RE: JMC Project 20044
 4 Tripp Lane Zoning Compliance
 4 Tripp Lane
 Town of North Castle, New York

Response to Kellard Sessions and Town of North Castle Planning Department Comments

This letter has been prepared to address comments and correspondence received from Kellard Sessions, dated September 22, 2023, the Town’s Planning Department staff report dated September 19, 2023, and HydroEnvironmental Solutions, Inc., dated September 22, 2023.

TREE & WETLAND MITIGATION PLAN
 PEREIRA RESIDENCE
 4 TRIPP LANE
 NORTH CASTLE, NY

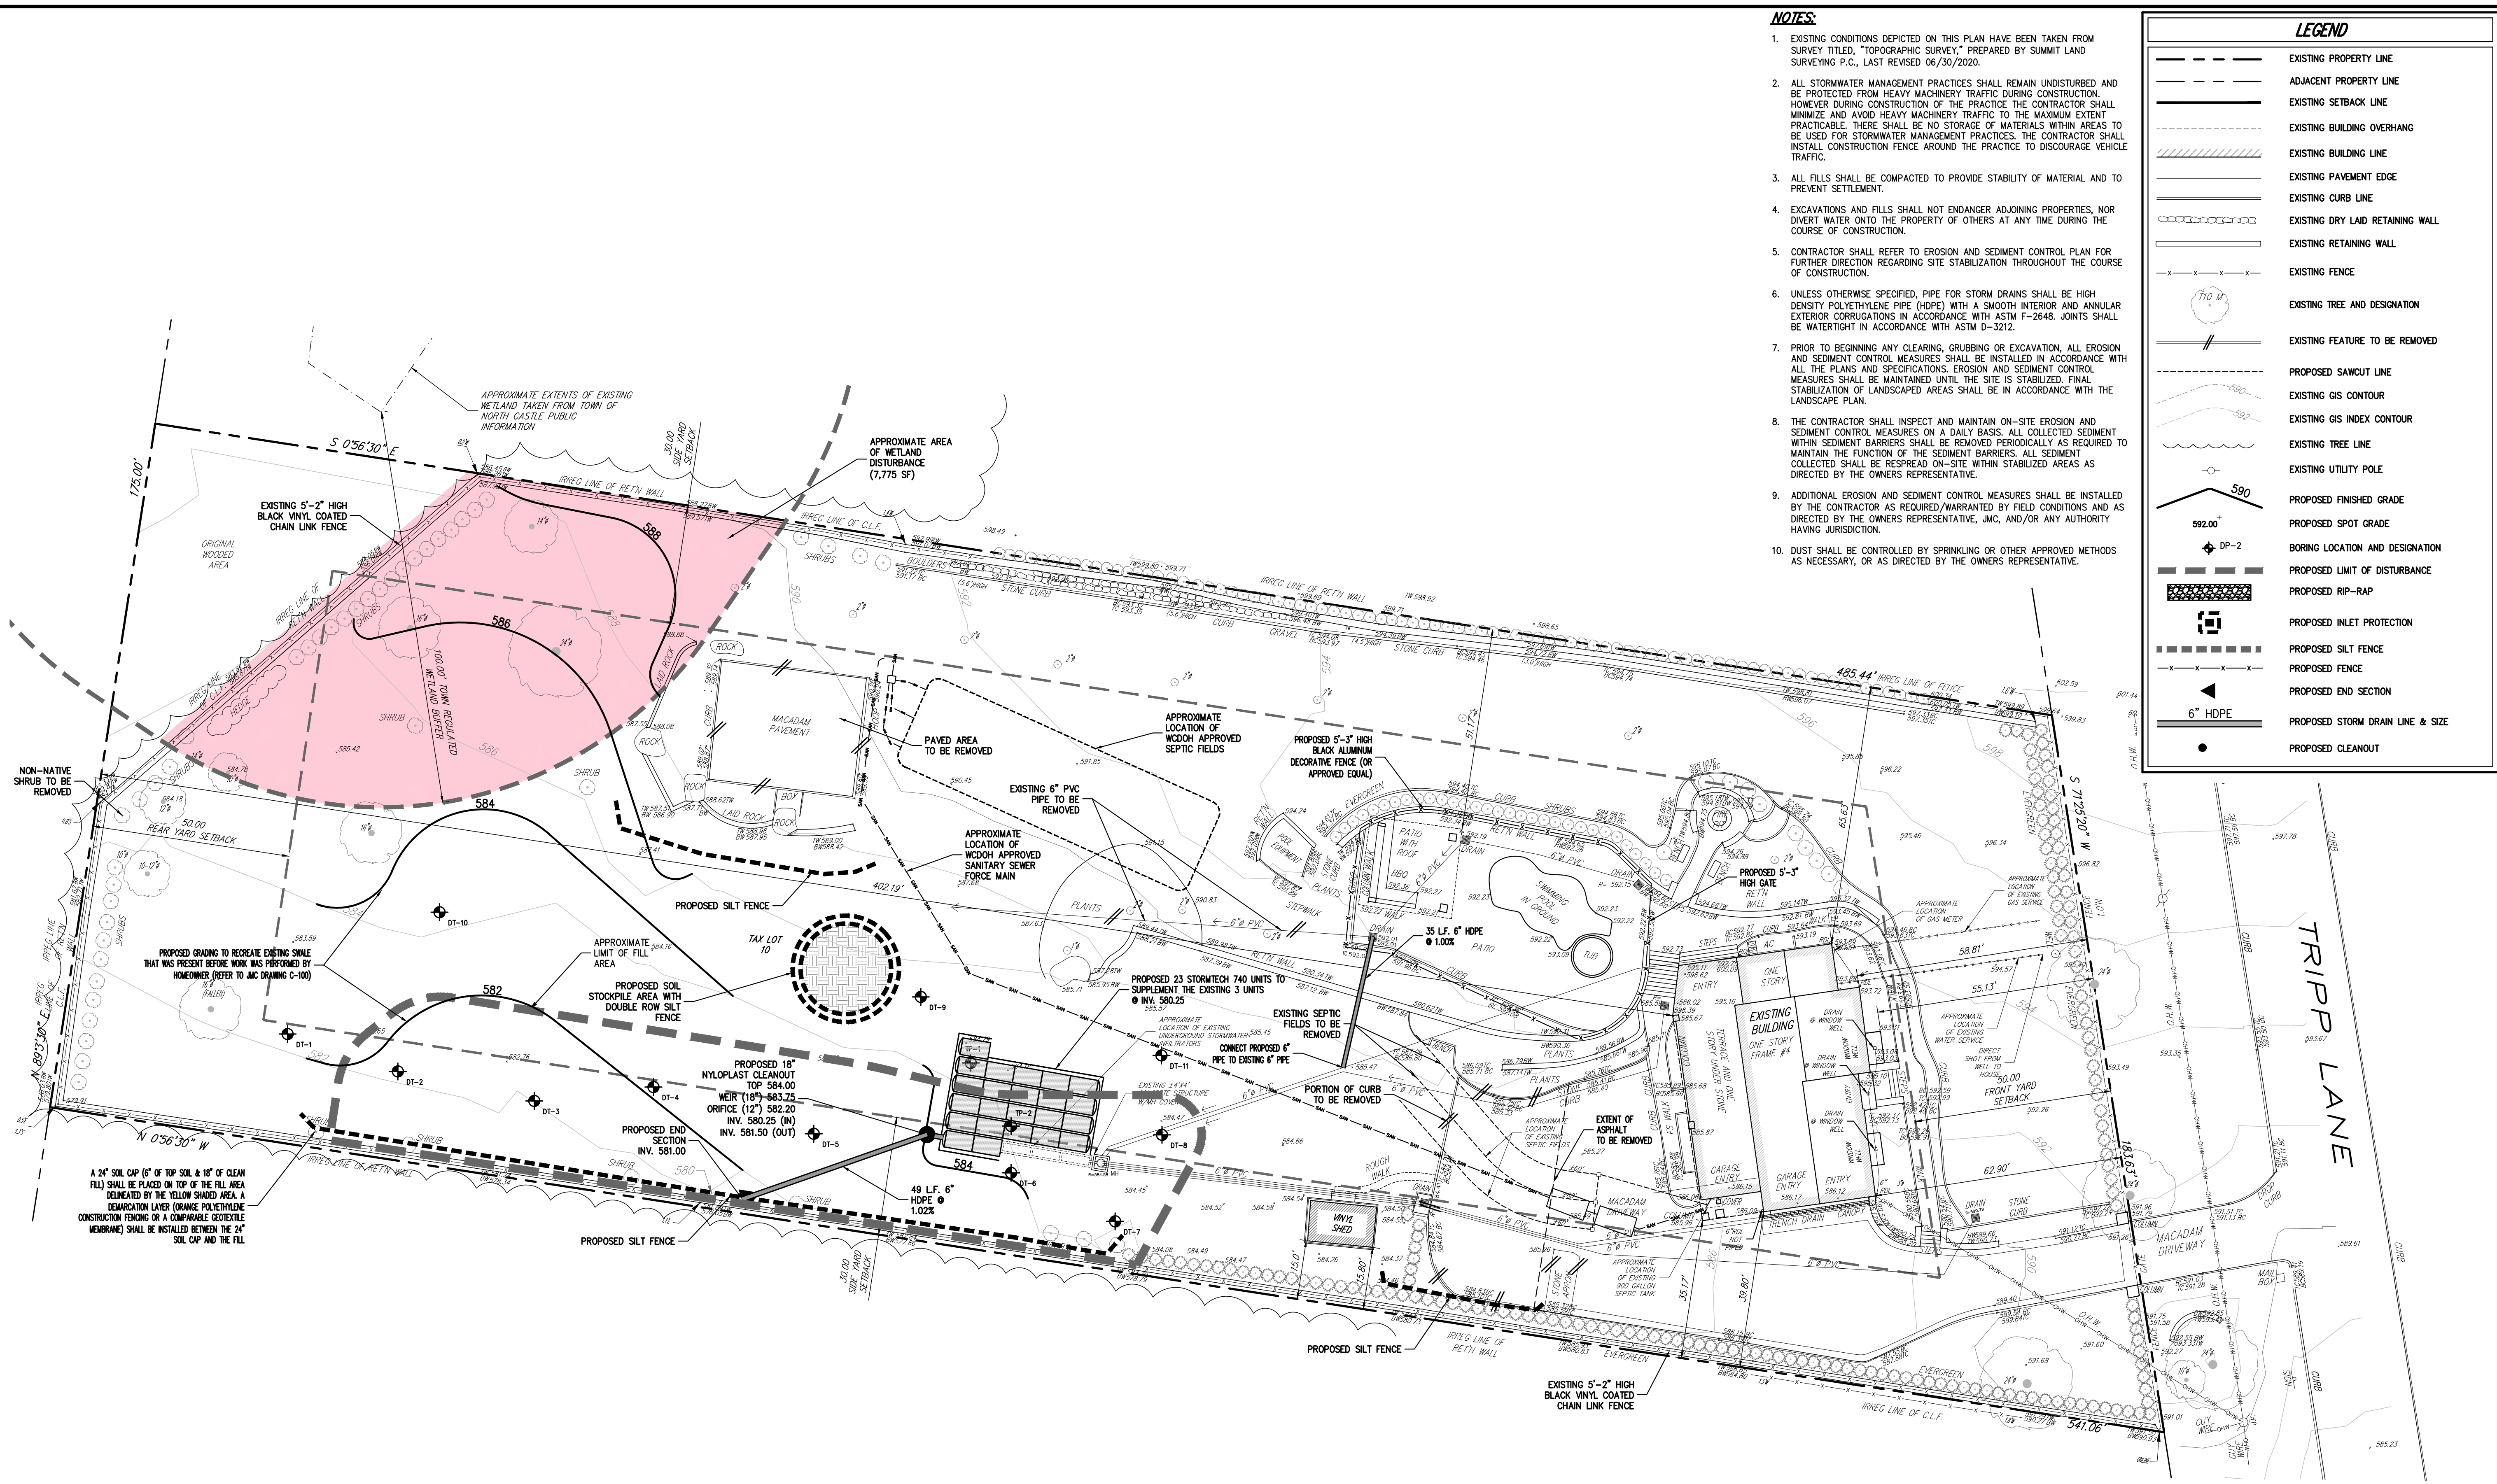
As previously requested, the Wetland Mitigation Plan shall illustrate and quantify the previous disturbance areas to the wetland and/or wetland buffer. The plan shall include a summary table that quantifies the total wetland and wetland buffer area on site, total disturbance areas within each, and total pervious and impervious cover pre and post development. Mitigation shall be provided at a ratio of 2:1 minimum. The plan currently indicates approximately 7,775 s.f. of disturbance within the wetland buffer. However, the applicant shall provide an updated wetland/wetland buffer disturbance area and required 2:1 mitigation based on the updated wetland delineation and available aerial mapping noted above. The plan shall include a detailed mitigation table quantifying disturbances and land cover (pervious/impervious) within the wetland and wetland buffer and the mitigation provided.

Section 308-25, the applicant will be required to provide a tree restoration plan to mitigate the unapproved removal of existing vegetation. The Planning Board will need to determine whether the restoration plan is ultimately appropriate for the level of disturbance and removals.

The Applicant has determined that approximately 171 trees were removed from the site. The plans have been revised to depict an approximately 16,000 square foot wetland buffer mitigation area; however, it is recommended that the site plan be revised to further replant new trees in the 1.15 acre area of previous tree removal.

A Wetland/Wetland Buffer Disturbance and Mitigation Table has been added to JMC Drawing C-130 that outlines the type of coverage within the wetland buffer area prior to any site improvements and the coverage after site improvements. It also quantifies the amount of wetland mitigation that will be provided after receiving site plan approval.

JMC Drawing C-130 has been updated with more proposed plantings in the rear area of the lot. It seems unfeasible to plant what would be required per the Town's mitigation requirements. The client looks forward to discussing this further with the conservation board about the best patch going forward to properly mitigate the tree removal.

JMC Drawing C-130 has been updated with more proposed plantings in the rear area of the lot. It seems unfeasible to plant what would be required per the Town's mitigation requirements. The client looks forward to discussing this further with the conservation board about the best patch going forward to properly mitigate the tree removal.

SITE PLAN
 PEREIRA RESIDENCE
 4 TRIPP LANE
 NORTH CASTLE, NY

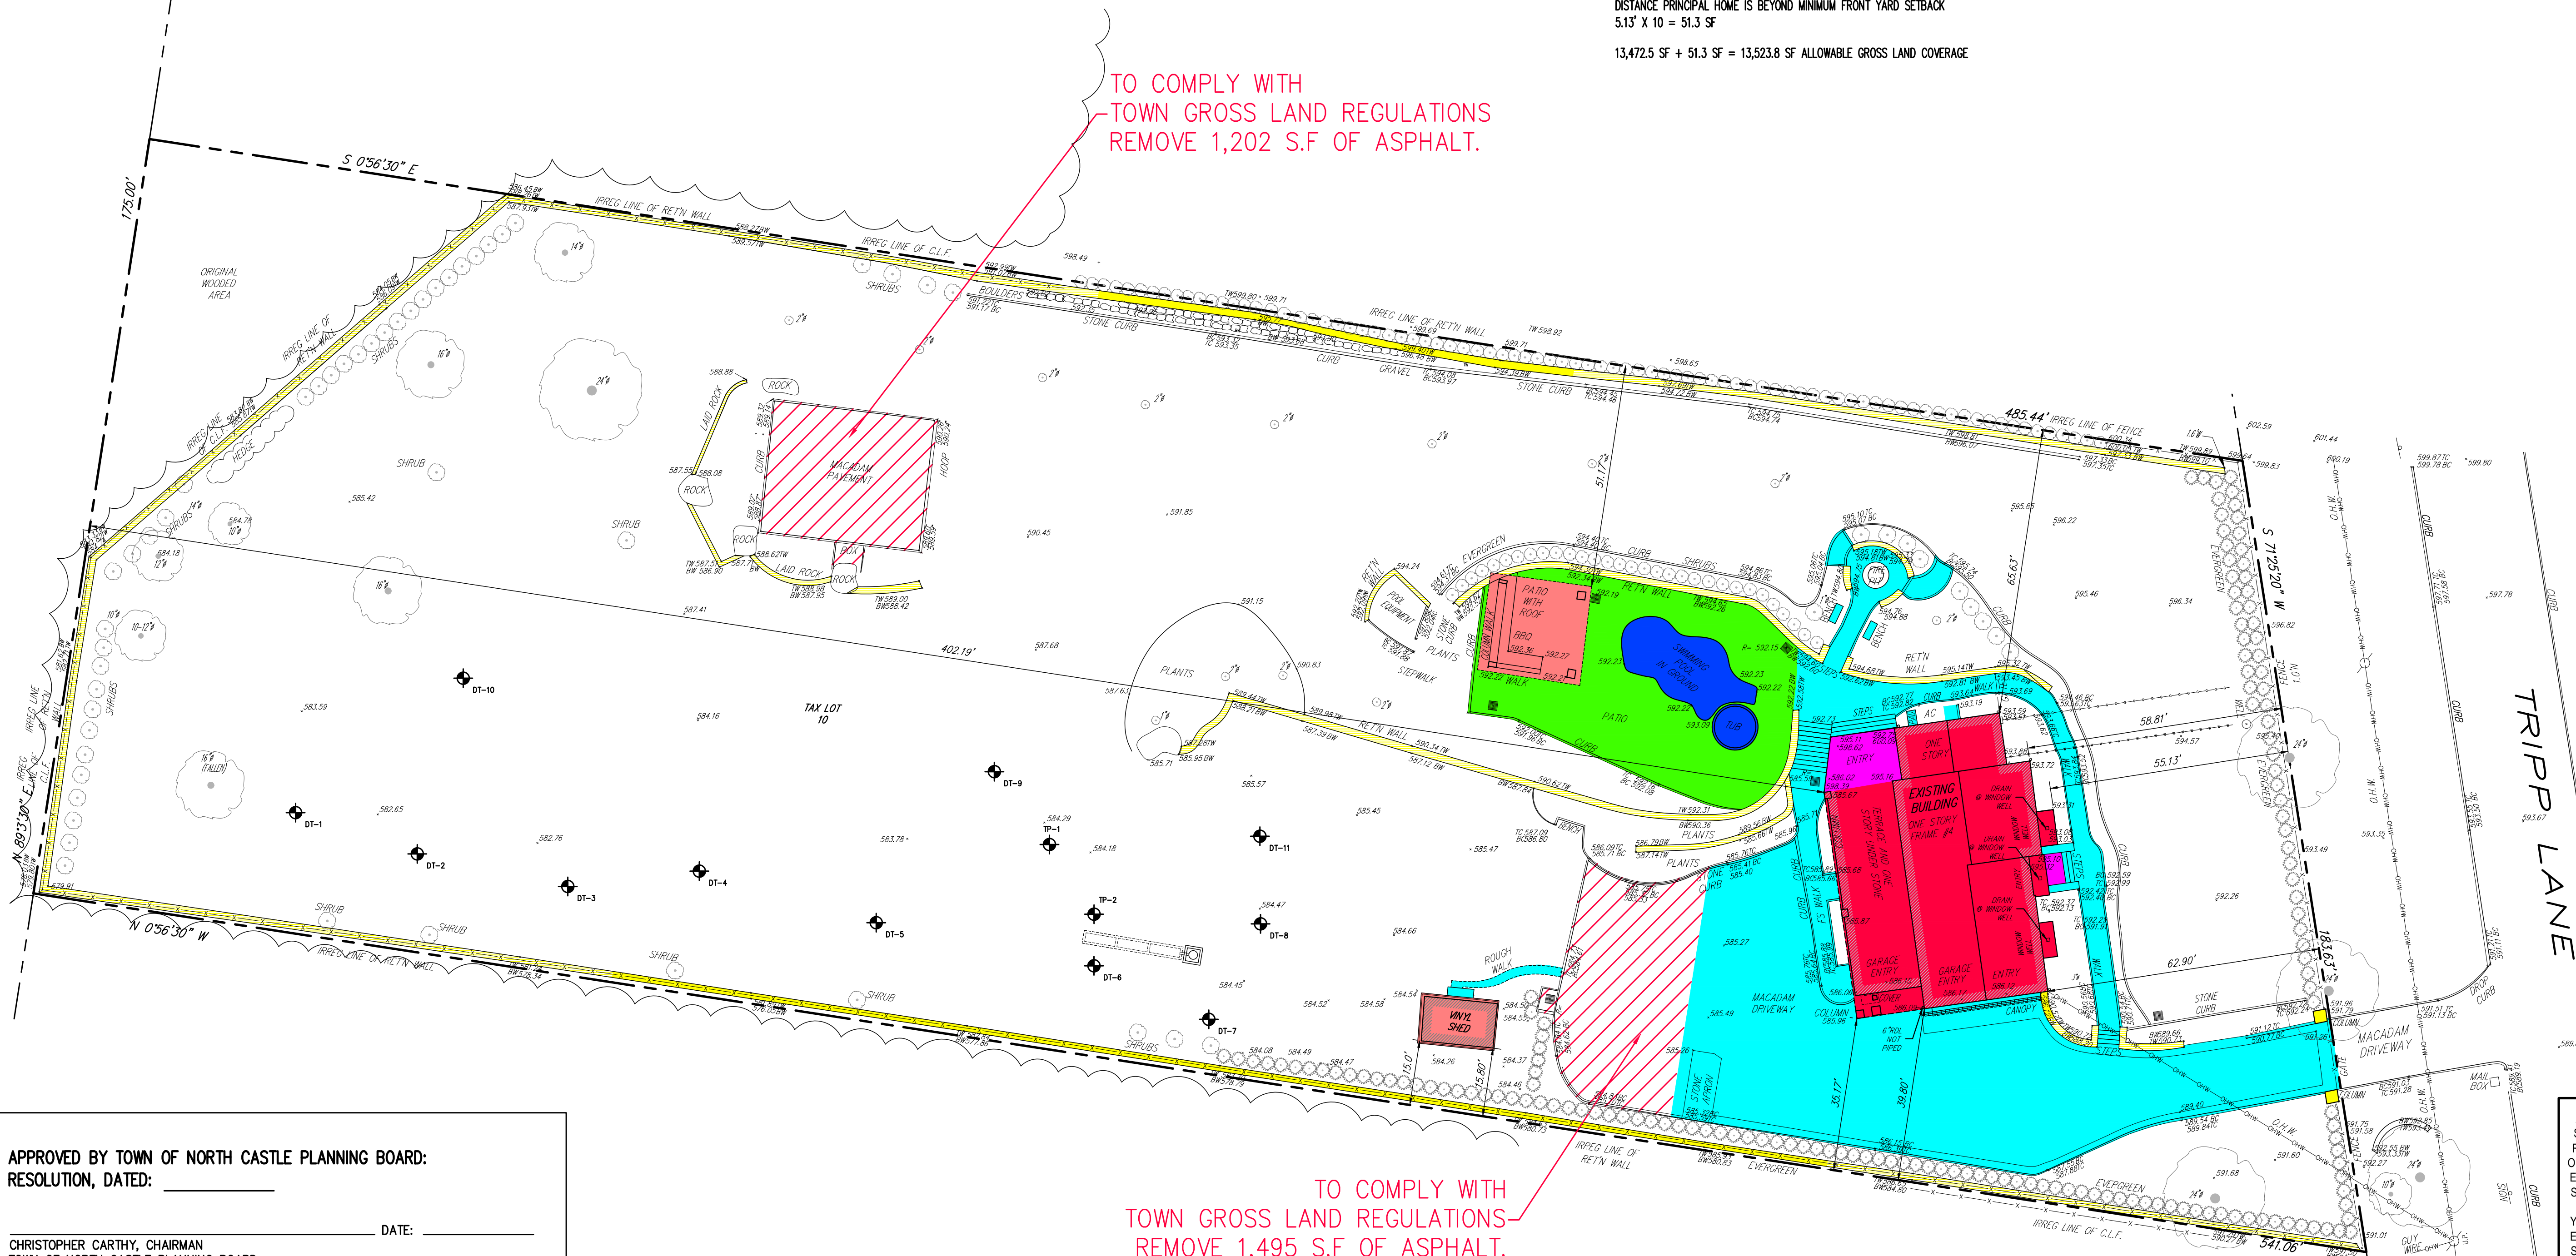
As previously noted, the applicant will be required to provide a Wetland Mitigation Plan in accordance with Chapter 340, Wetlands and Watercourse Protection of the Town Code, demonstrating a 2:1 ratio for mitigation of wetland and wetland buffer disturbance as a result of the project. The plan will require referral to the Conservation Board for recommendation of approval. Before an appropriate mitigation plan can be prepared for consideration, the limits of the existing wetland areas and associated buffers within and adjacent to the site must be established. Understanding that this is not possible for the subject property due to the fill placement, we note that as part of an ongoing application with the adjacent property to the east (2 Tripp Ln), this office verified that a locally regulated wetland exists at the rear of the site and is accurately depicted on the Tree Mitigation Plan. However, based on review of available Westchester County aerial mapping and topography, it appears that (prior to placement of fill) this easterly system was likely connected to a system on the west side of the property at 6 Tripp Lane through the subject property. The applicant will need to investigate this westerly off-site wetland system to identify the boundary and associated 100-foot wetland buffer. Additionally, a reasonable assumption based on historical mapping must be made to define previously existing wetland areas on the subject property. These areas should be included in the wetland/wetland buffer disturbance and required mitigation calculations. The off-site wetland boundary shall be field located and established with sequentially number flags for confirmation by the Town Wetland Consultant. Please notify this office once the wetland boundary has been established in the field.

As previously noted, the applicant has revised the Stormwater Management Report, as requested, to demonstrate adequate mitigation of the 100-year storm event. Please note the following:

- a. The plan shall illustrate the connection of the existing 6-inch pool patio drains to the infiltration system.*
- b. As a result of the wetland mitigation and required soil removal, total disturbance will exceed one (1) acre. As such, the applicant will be required to obtain coverage under the NYSDEC SPDES General Permit (GP-0-20-001) for Stormwater Discharges from Construction Activity and the submission of a Notice of Intent (NOI). Provide draft copies for review.*

JMC contacted the owner of 6 Tripp Lane to coordinate wetland mapping on their site and were denied access. A zoom meeting was then setup for Wednesday October 18th between JMC, the homeowner of 4 Tripp Lane, Kellard Sessions and the Town. It seemed that all parties were in agreement that with the information available, it does not appear that wetlands exist in the rear of the 6 Tripp Lane property. As shown on JMC Drawing C-100, there appeared to be a natural swale that runs through the back of the subject property and the grading has been updated on JMC drawing C-200 to recreate this swale to the best extent possible.

JMC Drawing C-200 has been updated to now show a proposed 6" pipe from the furthest downstream pool inlet connecting into an existing 6" pipe that is currently being conveyed into the existing underground stormwater mitigation system that will be enlarged to accommodate the increase in impervious coverages.
